Groundwater Application Review Summary Form

Application # G- 18679 RR

PUBLIC INTEREST REVIEW FOR GROUNDWATER APPLICATIONS

A. GENERAL INFORMATION: Applicant's Name: Silver Oak Wine Cellars, LLC County: Yamhill

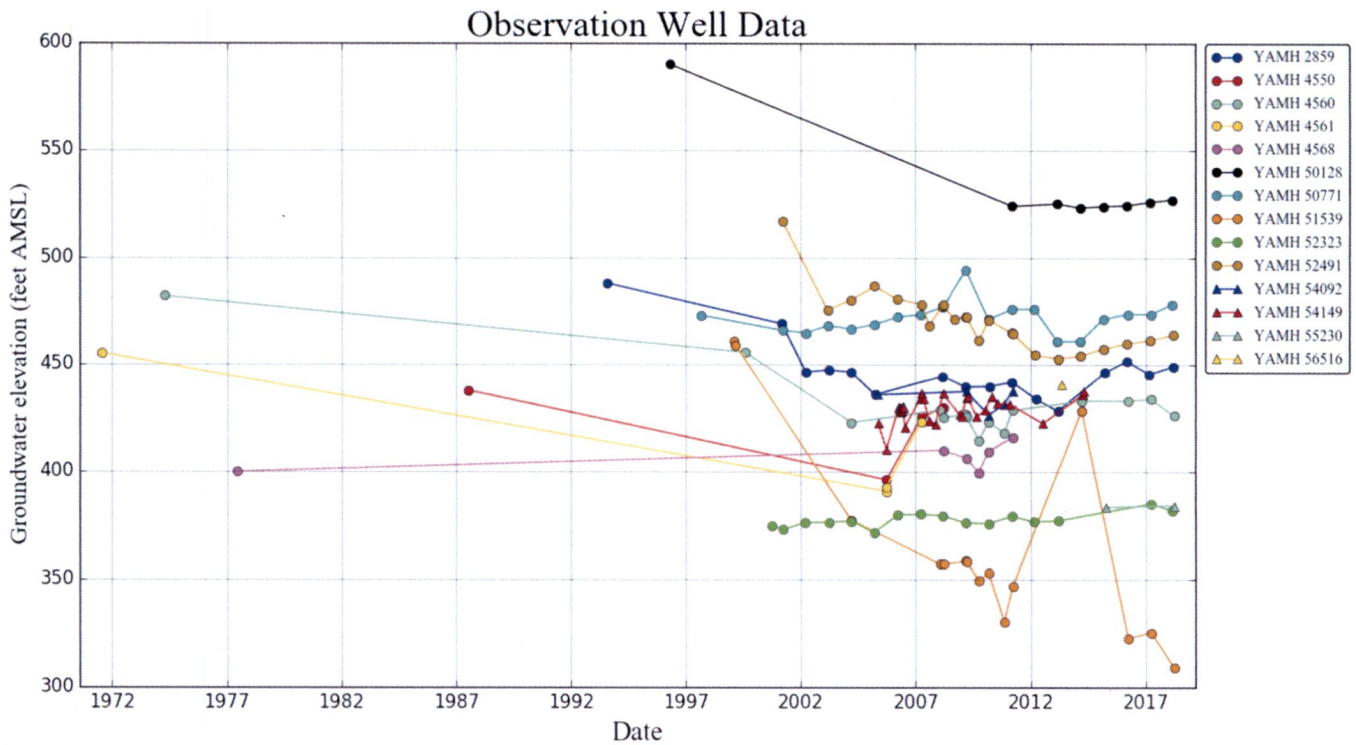
The proposed use of 7.5 acre-feet per year at a maximum rate of 31 gallons per minute (gpm) is unlikely to create drawdown interference with nearby wells that prevents access to water. Nearby wells access a variety of water-bearing zones within the CRBG aquifer system. Well logs in T3S/R3W- Sections 22 and 27 report yields ranging from 1 to 364 gpm, with a median yield of 25 gpm. Wells that access the upper elevation water-bearing zones show reasonably stable trends (see Figure 3), while wells that access the lower elevation water bearing zones show slightly more long-term decline. The subject wells are expected to access upper elevation water-bearing zones, with a water-level elevation of approximately 500 ft above mean sea level. The proposed magnitude of development is not expected to cause injurious well-to-well interference with neighbors or long-term water level decline. Water use and water level monitoring conditions are recommended to protect existing users.
